PART VI | COMPARISON DRAWINGS

107 HIGH STREET, LINDFIELD, HAYWARDS HEATH, RH16 2HR

**PART VII | PROPOSED REGULARISATION
OF SCHEME**

PROPOSED REGULARISATION OF SCHEME
SUMMARY

COMPARISON - NORTH ELEVATION. 1:50@A3

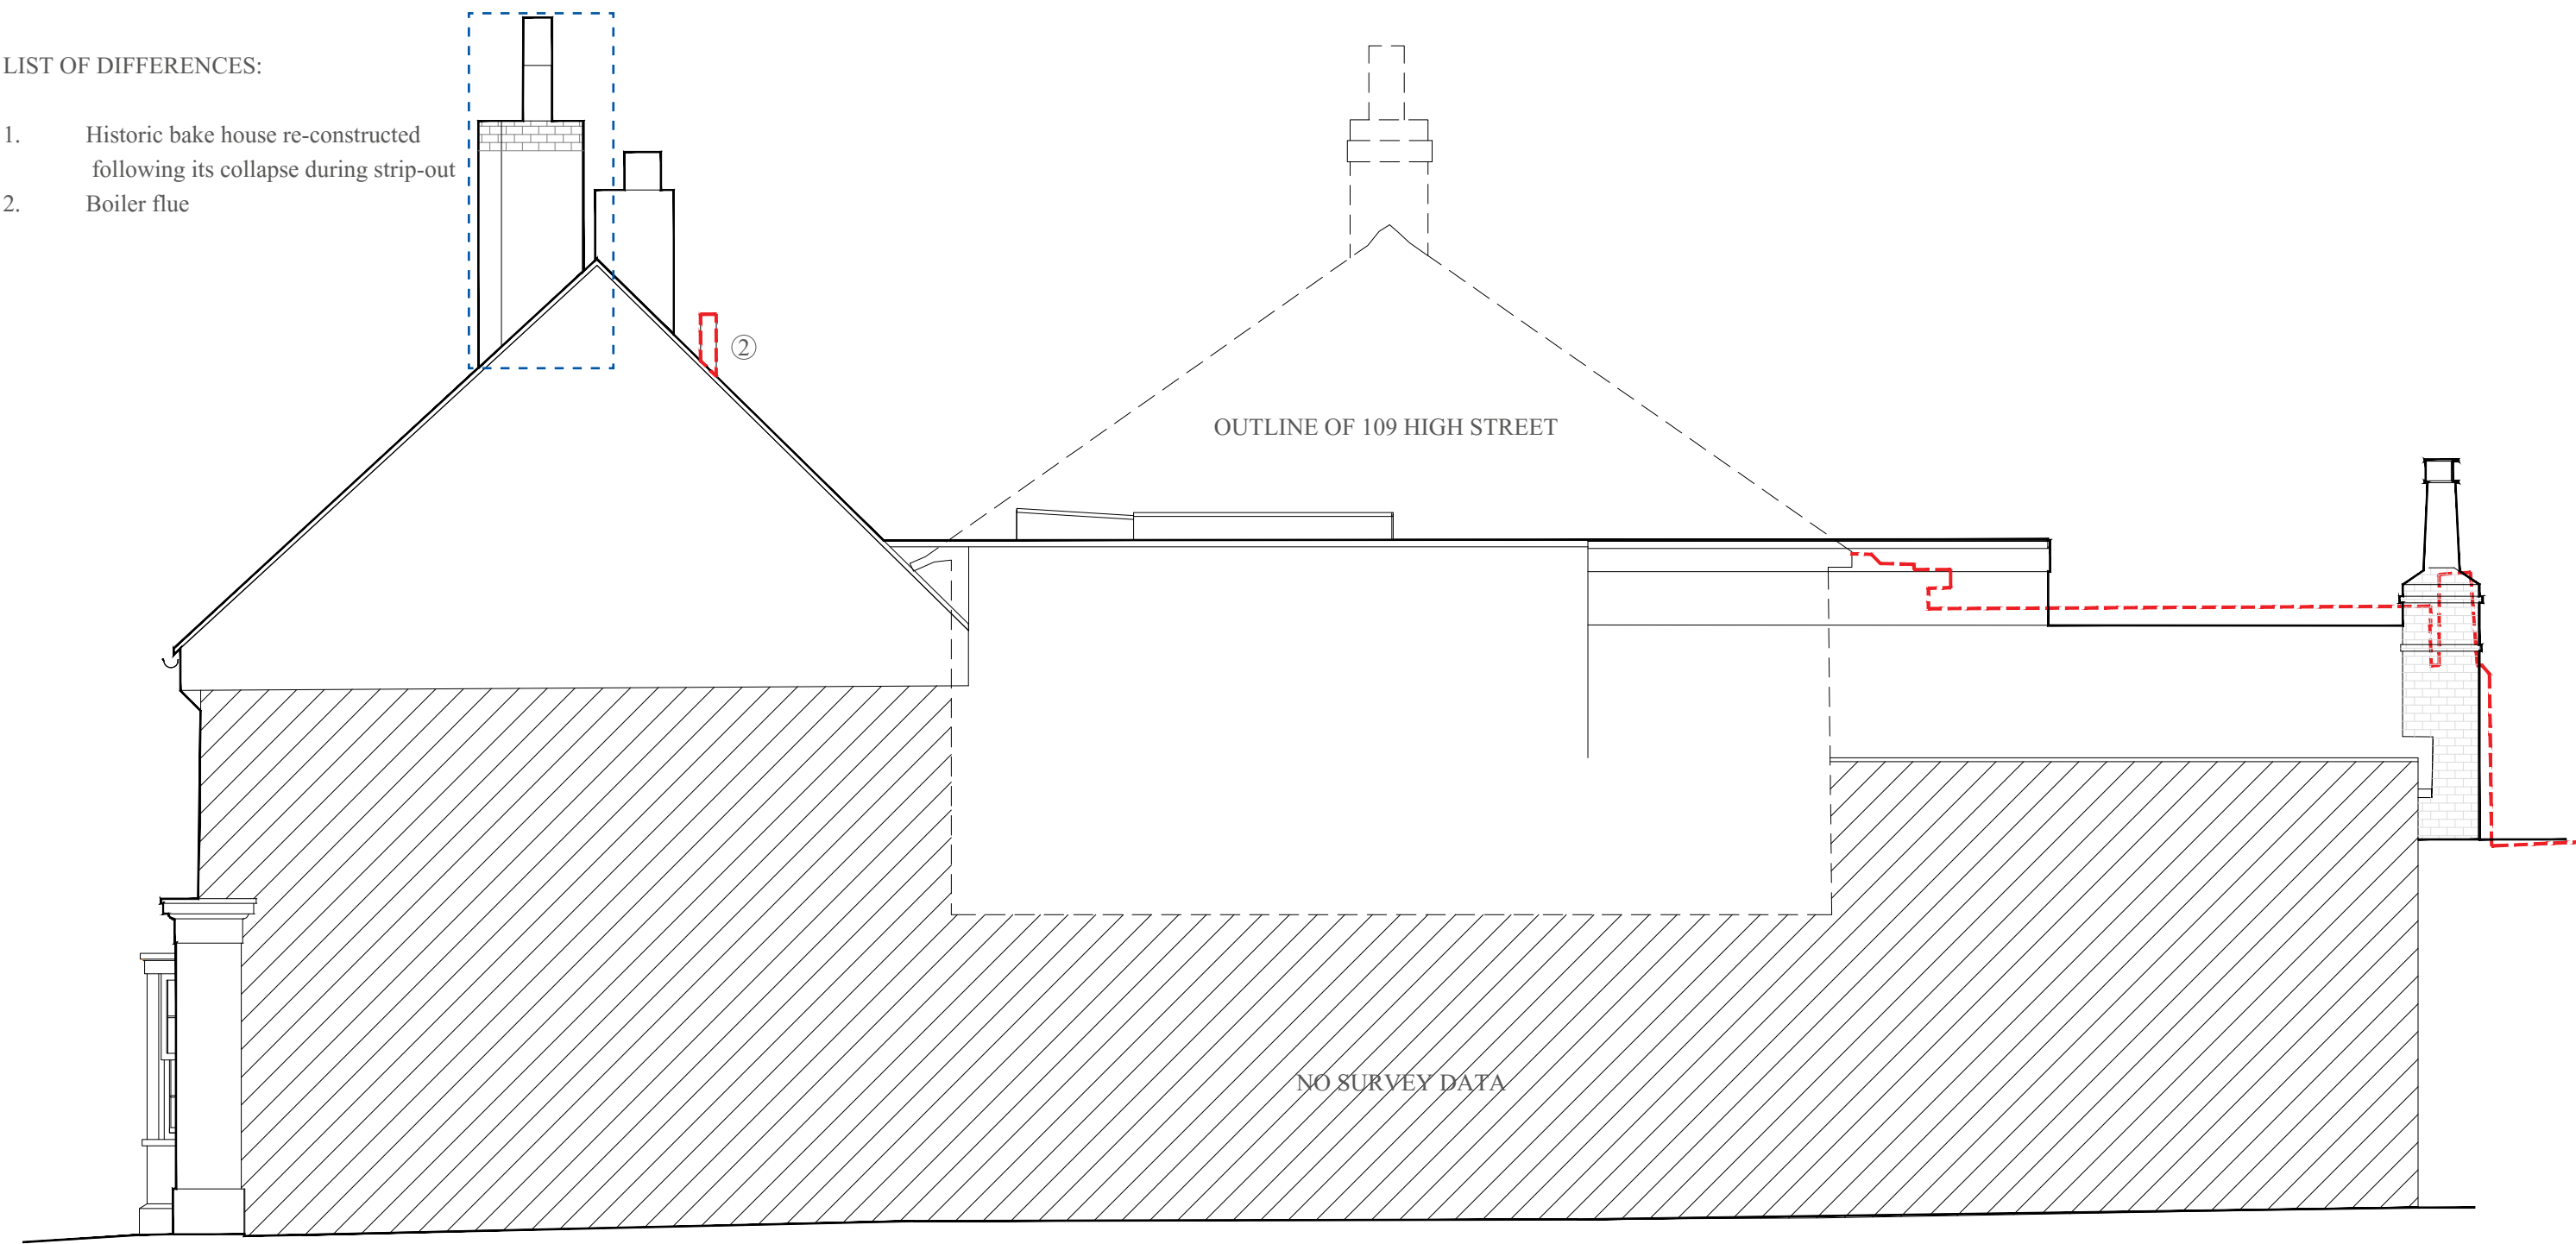
1. Historic bake house re-constructed following its collapse during strip-out
2. Boiler flue

COMPARISON - SECTIONAL ELEVATION AA REV A. 1:50@A3

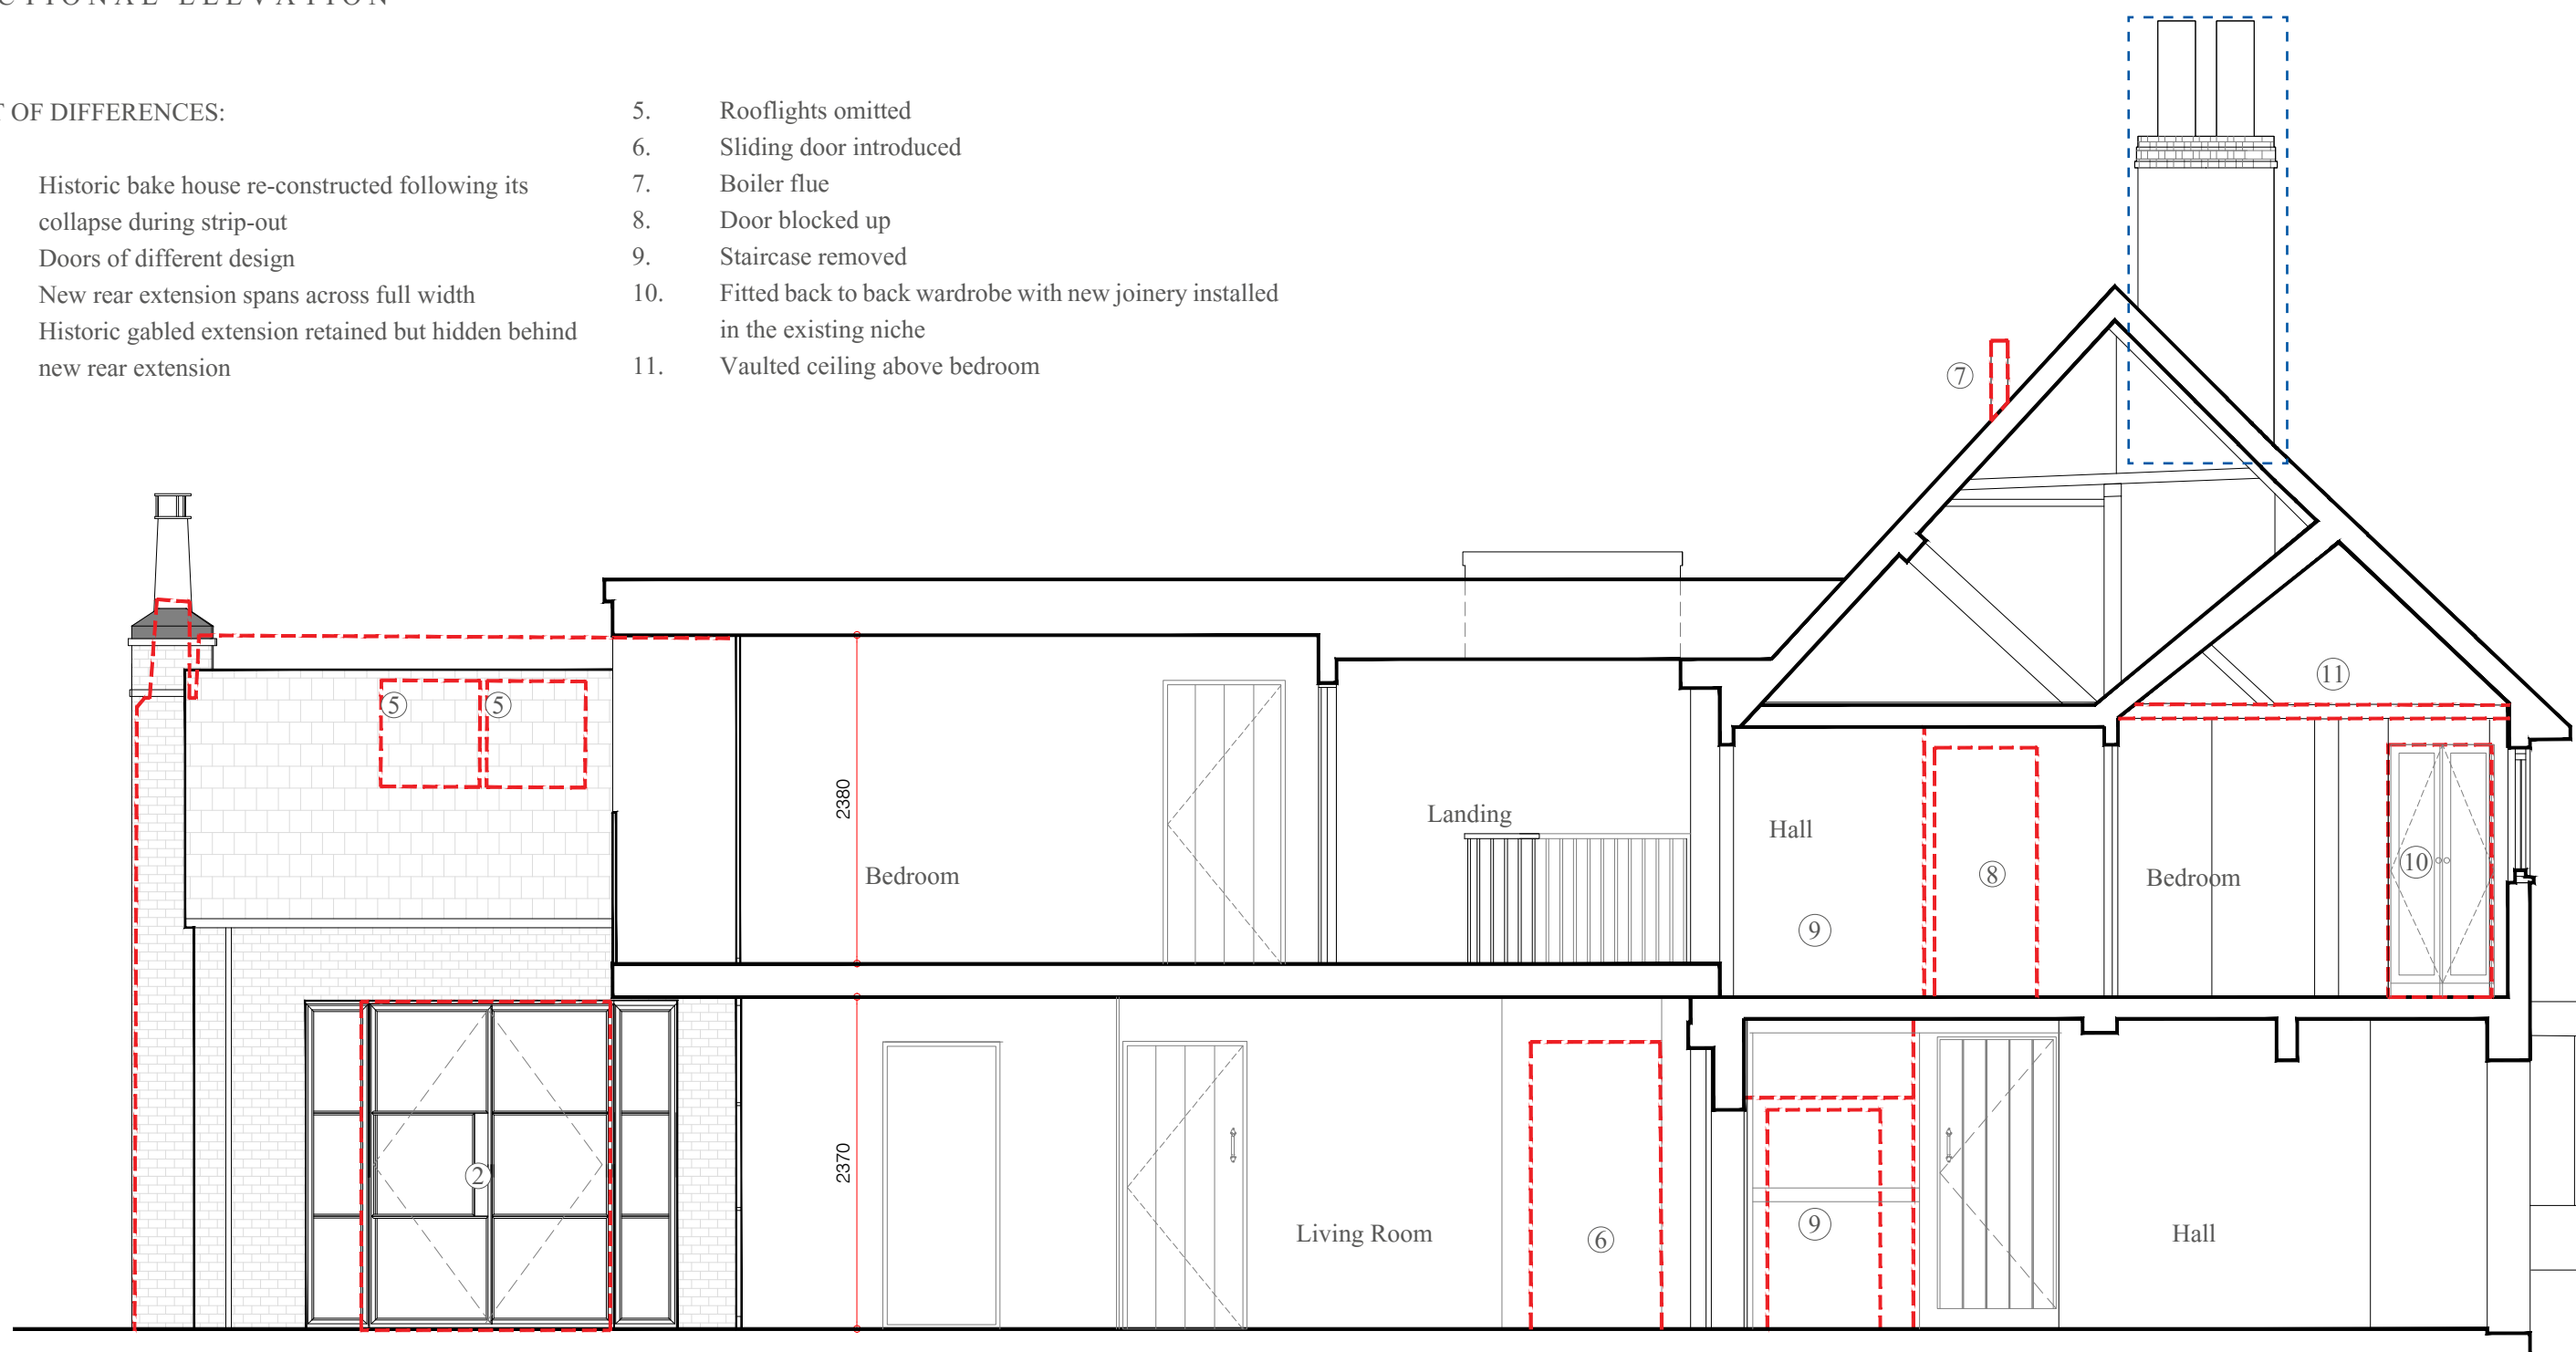
| 1. | Historic bake house re-constructed following its collapse during strip-out | 5. | Rooflights omitted |
| 2. | Doors of different design | 6. | Sliding door introduced |
| 3. | New rear extension spans across full width | 7. | Boiler flue |
| 4. | Historic gabled extension retained but hidden behind new rear extension | 8. | Door blocked up |
| | | 9. | Staircase removed |
| | | 10. | Fitted back to back wardrobe with new joinery installed in the existing niche |
| | | 11. | Vaulted ceiling above bedroom |

PROPOSED SITE PLAN. 1:300@A3

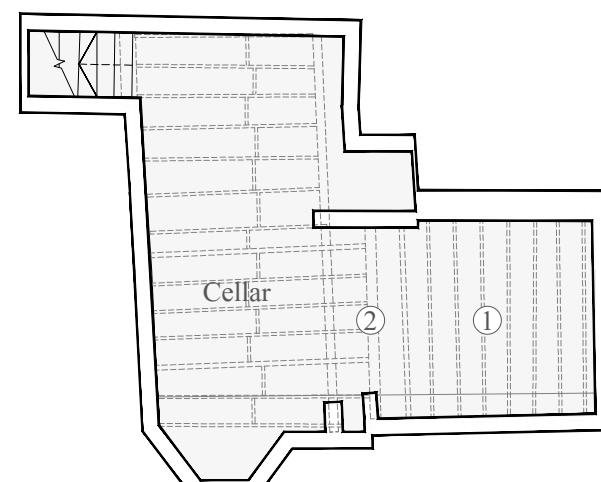
1. Garage - to remain as implemented
2. Landscaping - to remain as implemented
3. Rear extension spans across full width - to remain as implemented
4. Historic bake house re-constructed following its collapse during strip-out- to remain as implemented
5. Pergola - seeking permission - to remain as implemented
6. New gates - to remain as implemented
7. New bin store - to remain as implemented
8. New ornamental arch - seeking permission to remain as implemented
9. New timber irrigation tank enclosure - seeking permission to remain as implemented

PROPOSED GROUND FLOOR PLAN REV A. 1:100@A3

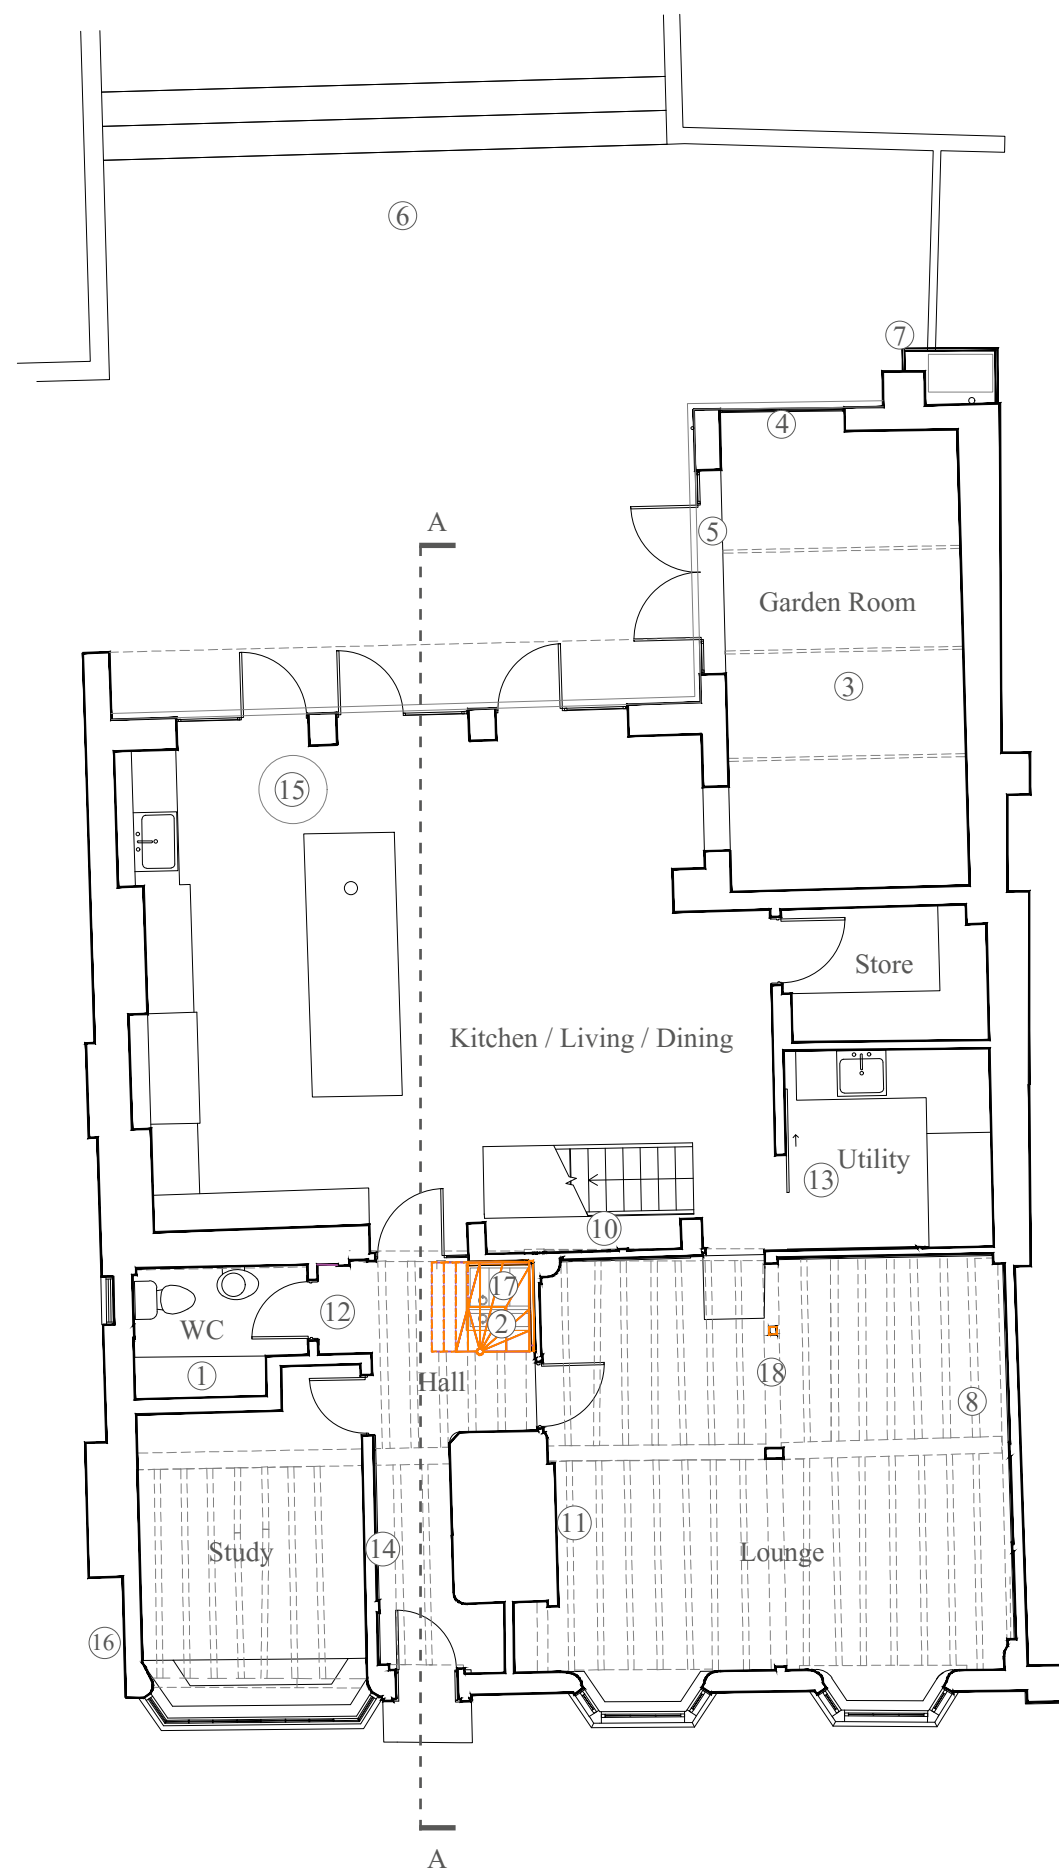
1. Change of layout - WC added *
2. Existing joinery and staircase: non-original joinery omitted, staircase to be reinstated in a form close to the original

3. Historic bake house re-constructed following its collapse during strip-out. *
4. Window of different design *
5. Doors of different design *
6. Landscape of different design *

7. AC AHU louvred timber enclosure - matching timber of new extension *
8. Existing chimney stack removed *
9. Glass covering of historic well (discovered during construction works) *

10. Removal of internal 1990s casement windows to box framing of 15th century west wall, openings filled in with timber stud framing, wood wool boards and lime plaster *

11. Re-facing of main chimney breast to ground and first floor rooms in reclaimed brick in hydraulic lime mortar incorporating new hearths *
12. Removal of timber stud wall with stone veneered nogging at ground level to create a reveal / recessed entrance to WC is proposed as implemented. *

13. Sliding door partition to wine cellar / utility room, partition wall in different location *
14. New timber walling *
15. Re-discovered well *
16. Timber weatherboarding not continued to ground level*

17. Existing basement access hatch modified to allow for opening underneath the reinstated steps
18. Plaster infill wall removed, door jamb to ground floor northern room reinstated to make legible an original stud partition but which was heavily altered in the 20th century
